Determination 2008/61

Dispute about the code compliance of two proprietary flashings installed on the roof of a house at 37 Meadowcroft Grove, Johnsonville, Wellington

Figure 1: Section showing typical installation details

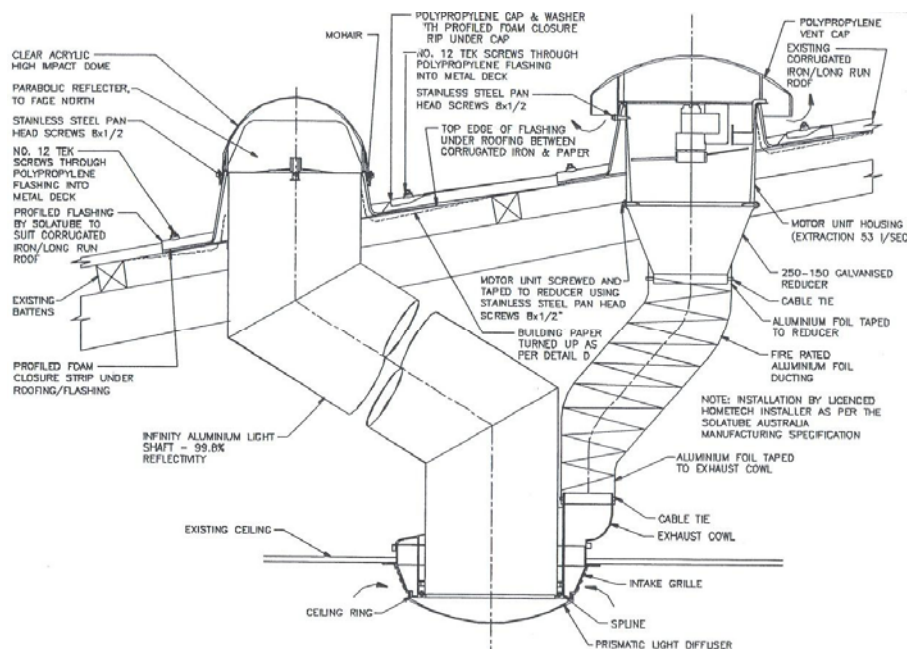
- 6.8 The territorial authority has said that the flashings do not comply with Building Code Clauses E2.3.2 and E2.3.7, however, it has not said in what specific respects the flashings do not comply.

- 6.11 The territorial authority has cited disadvantages associated with the use of surface-fixed EPDM boots. However, the flashing differs from an EPDM boot in several important respects: the flashing does not rely on sealant to achieve weathertightness nor is it lapped over the roofing to create any dam to trap either moisture or dirt.

- 6.12 I acknowledge that the flashing does restrict the trough profile but even if water is restricted in its movement down the roof, its temporary build-up will not lead to water ingress through any weak points in the flashing.

- 6.15 In my view the documentation presented with the application was not sufficient to demonstrate compliance with the Building Code. The drawings were for the installation of the flashing into a corrugated steel roof. However, the metal roofing in this instance had a trapezoidal profile. The drawings did not clearly show how the critical top, bottom, and side laps were to be constructed. How these junctions were to be made weathertight was only made clear to me when the sample flashing was provided. An expanded view of the complete flashing assembly would also assist.

- 6.17 In this case the flashings are purpose made items that are mounded to the profile of the metal roofing. They can therefore be effectively sealed around the full perimeter of the roof penetration while still providing the appropriate lap direction. The flashing does not require the installation of an EPDM boot.

- 6.20 I accept the evidence presented by the applicant that the flashings have a proven history of performance that can be used to demonstrate compliance with Building Code. I conclude that the flashings as installed comply with Clause E2 “External moisture”.

Figure 54: Soaker flashing for pipe penetrations
Paragraphs 8.3.10 and 8.4.17 b)

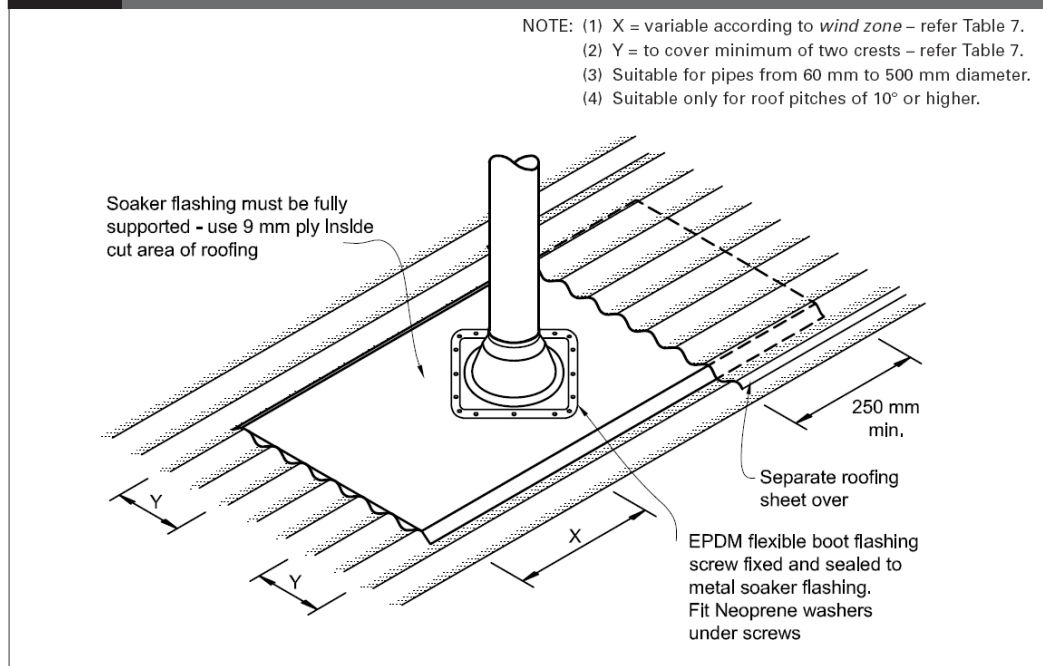
- 6.2 For pipe penetrations of 250mm diameter to the roof to this house, E2/AS1 prescribes the use of a soaker flashing which is lapped with the metal roofing as described in Figure 54. This prescribes a minimum top lap of 250mm, a bottom lap of 130mm and side laps of 230mm.

- 6.3 Except for the down-turn to its edges, the soaker flashing is flat and not moulded to the profile of the metal roofing. There is no requirement for specific fixings, foam seals, closure pieces or similar, to close the gaps between the flat soaker and the metal roofing. The laps to the soaker flashing must therefore be sufficiently big to compensate for wind-blown rain being driven up or along the laps.

- 6.4 The soaker flashing is fitted with an EPDM boot that forms the seal to the pipe. . The EPDM boot is surface-fixed and sealed to the soaker flashing: a typical EPDM boot has a sealed lap width of approximately 20mm. In addition, the EPDM boot is also required to be sealed to the pipe itself.

- 6.16 Figure 54 of E2/AS1 describes a solution for the worst case situation for a roof of this type, pitch and exposure using standard materials and fittings. The minimum laps shown are to compensate for the use of a soaker flashing that is unable to be adequately sealed to the roof profile. Figure 54 shows the use of an EPDM boot which adds two more junctions which must be rendered weathertight.

- 6.18 There are significant differences between the situation shown Figure 54 and the flashings as installed on the house. I do not consider that the minimum laps described in Figure 54 are relevant in this instance.

- 6.19 The installation detail sought by the territorial authority appears to duplicate the soaker flashing shown in Table 54. However, the rigid boot is surface-fixed to the soaked flashing which is reliant on proper sealing of this junction which, in my view, cannot provide a more robust weathertight joint than that already offered by the applicant using the standard installation details for the flashing.
